# Proposed content for IL budget in 176E

Associated comments: 412, 515, 144, 411, 566

Adee Ran, Cisco

**Figure 176E-1—Components of a 200 Gb/s per lane AUI-C2M ~~and insertion loss budget at 53.125 GHz~~**

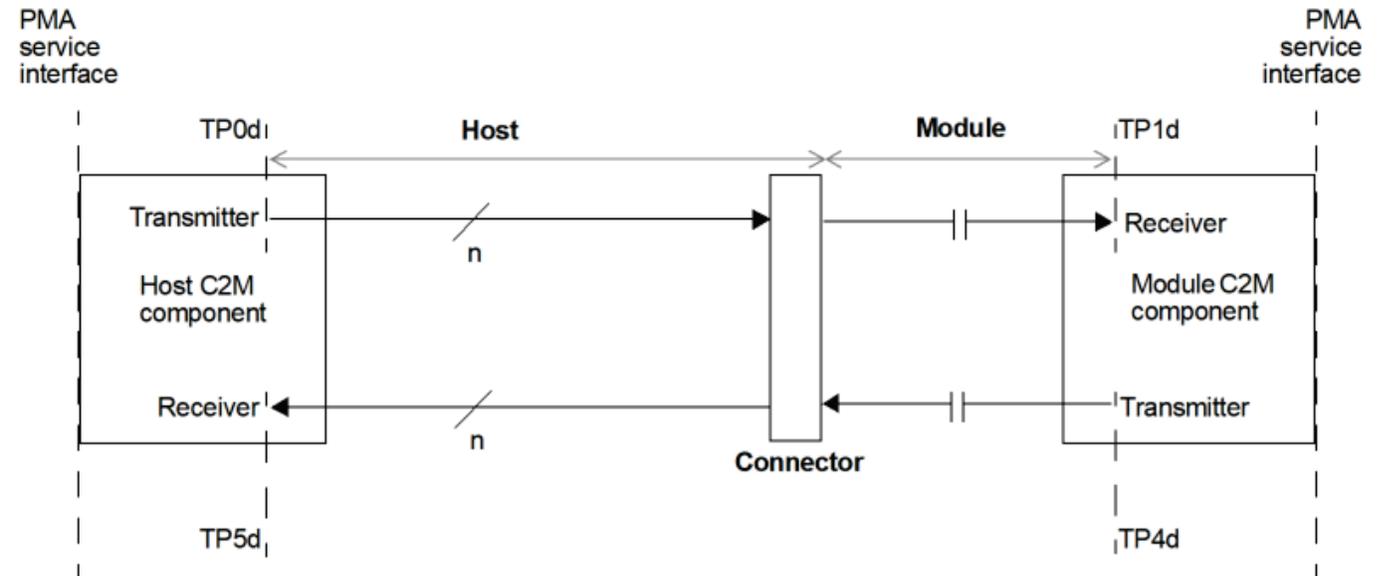
- Both comment 412 and comment 515 suggest that the loss values should not appear in this figure, which is intended to depict a functional model.
  - The suggested remedy in 412 is to add a table in 176E.5.1 with recommended loss values instead.
  - The suggested remedy in 515 is to create a new related diagram in 176E.5.
  - Both options are presented; we should choose one.
- Additional comments address this figure:
  - 144 and 411 suggest redrawing for clarity of what the different boxes are. The suggested changes are shown on the next slide.
  - 115 suggest specific numbers for the TBDs. ~~The numbers are not addressed in this presentation.~~ **Based on straw poll #E-1 there is consensus to use TP0d-TP1a ILdd of 32 dB.**

*Editor's note: Figure 176E-2 is intended to show die to die ILdd values, i.e., including packages where applicable. This is currently indicated by the test point designations TP0d, TP1d, TP4d, and TP5d, although these notations have not been adopted for this annex. Contributions on how this information is to be depicted in the diagram are encouraged.*

Figure 176E-2 depicts a typical 200 Gb/s per lane AUI-C2M application ~~and the associated ILdd budget at 53.125 GHz. This ILdd budget represents a minimum capability that components are expected to support.~~ The recommended characteristics of the channel between the C2M components are provided in 176E.5.

### 176E.5.1 Reference insertion loss budget

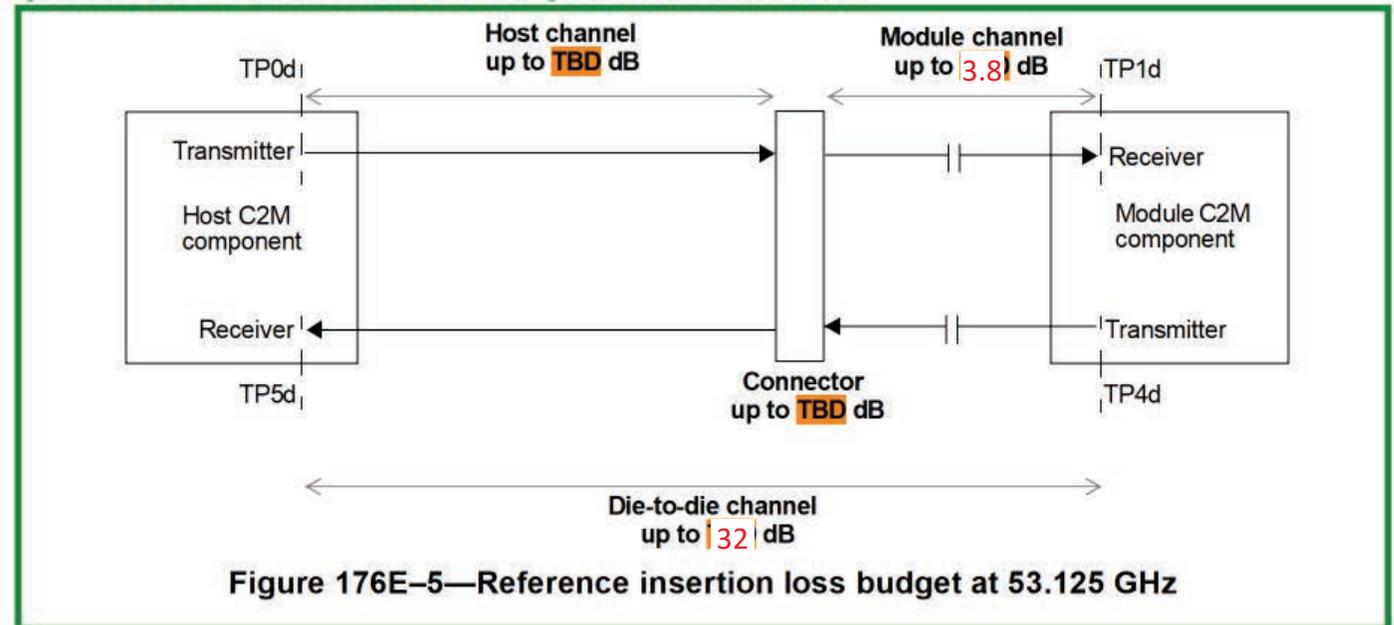
Fill in missing numbers based on resolved comments

Figure 176E-5 depicts the reference differential insertion loss (IL<sub>dd</sub>) values at 53.125 GHz for specific parts of the channel between the C2M components and for test fixtures associated with host and module specifications. The insertion loss is not expected to be measurable.
